Case B-015
BRADFORD RANGER DISTRICT
OGM ANALYSIS

Subject: US Energy 35 Well Package Dated February 14, 2008

Figure 1 - Approximate location of Section 16 Development

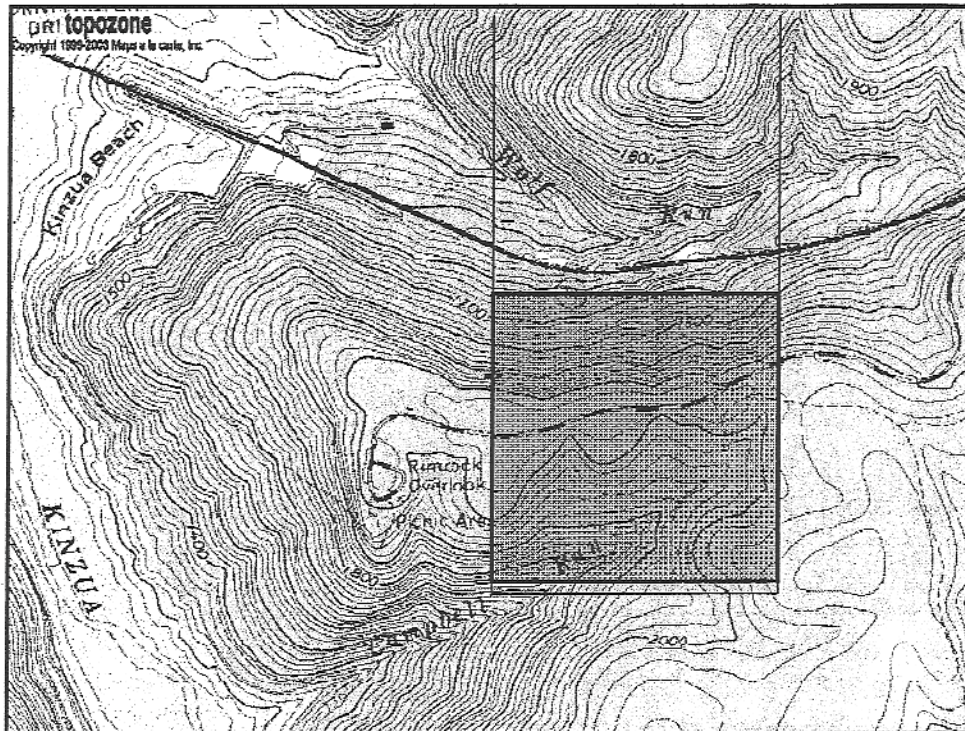
Given that the general location of this proposal is in the immediate proximity of the Rimrock Overlook and appears to directly impact the Rimrock Trail I am concerned that the level of development and associated impacts may exceed the threshold for RN ROS for trail and to a lesser extent possibly the Overlook. This development may also drastically alter the scenic quality of the area due to the level of development and placement on the landscape and possible visibility from the Allegheny Reservoir or the Longhouse Scenic Byway. Given the density of the development, and an unknown but certain road and pipeline development scenario it appears that impacts on the trail itself will be severe. Impacts would be evident from noise associated with initial road construction and well development followed by periodic automated pumping. Impacts would be evident due to road, well pad, and tank battery construction. Impacts would also be noticed through a dramatic rise in activity and encounters of visitors with the industrialized development found in this section as well as neighboring sections that are planned for similar development. There are also possible impacts to the Rimrock Road, SR 59 and possibly the Allegheny Reservoir that I cannot determine due to the lack of geographical information in the proposal. It appears that these wells are developed on an approximate 500' centerline.

To give an adequate and professional evaluation I need more specific information about the location of each well and how it relates to Rimrock Trail, Rimrock Road, the Overlook, the Allegheny Reservoir (whether it is on the plateau or on the sideslope), and SR 59. Without more definitive information my analysis is speculative.
